# Administrative Approval Action

Case File / Name: ASR-0050-2020  
5825 North Hills

**REQUEST:** Development of a 5.52 acre/240,451 sf tract zoned RX-4-PL-CU (zoning conditions of Z-41-2019) into two apartment style buildings with a total of 97 units. The site includes right-of-way dedication of .06ac/2,614 sf leaving a net area of 5.46 ac/237,838 sf. One of the proposed buildings will be 102,753 sf with 45 units and the other building will be 121,720 sf with 52 units for an overall total building area of 224,473 sf.

LS1.00

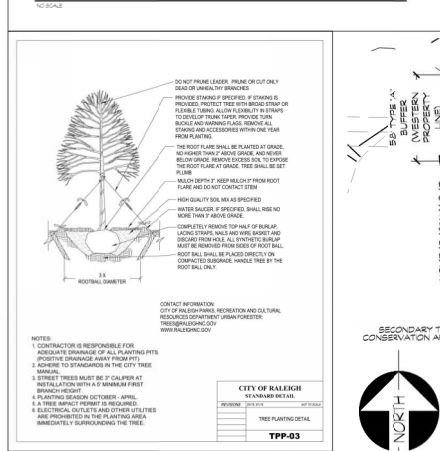
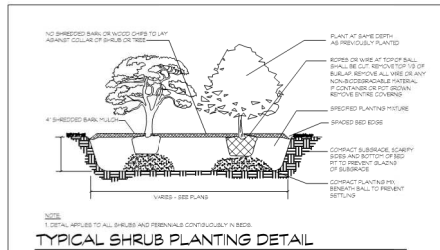
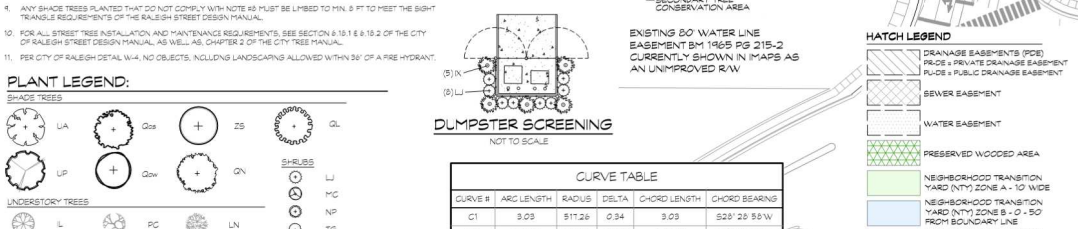
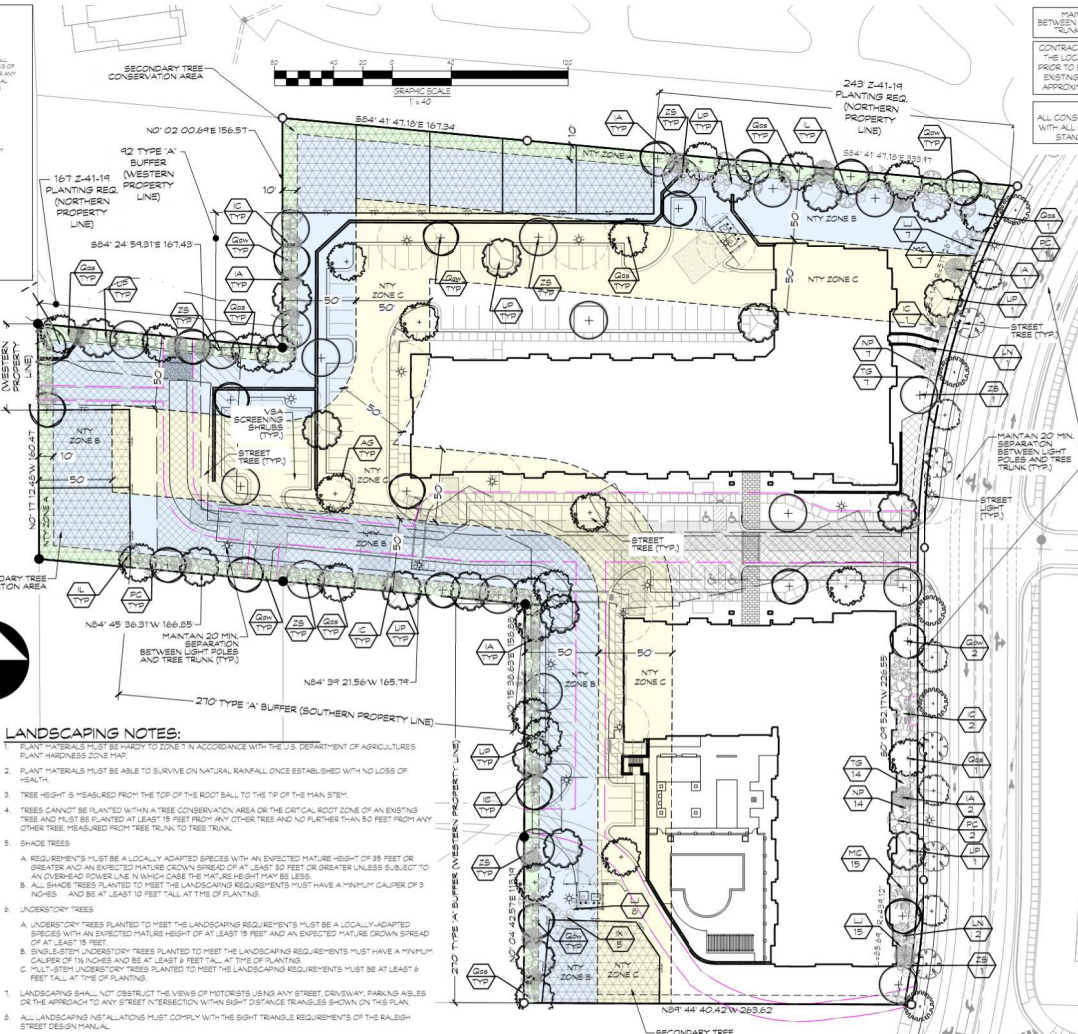
1. The Site Permit Review plans landscaping sheet LS1.0 shall conform with the required Neighborhood Transition Yard design requirements in UDO Section 3.5.3. Sheet LS1.0 shall be amended to show the required fencing/wall and corrected shrub count total per UDO Section 3.5.3.A. & Z-41-19 along all exterior lot lines abutting residentially zoned properties, outside noted the tree conservation boundary areas.
2. The proposed lighting fixture and/or tree planting location behind Building #2, shown on sheet LS1.0, is revised to demonstrate compliance with Sec.7.1.7.G of the UDO.
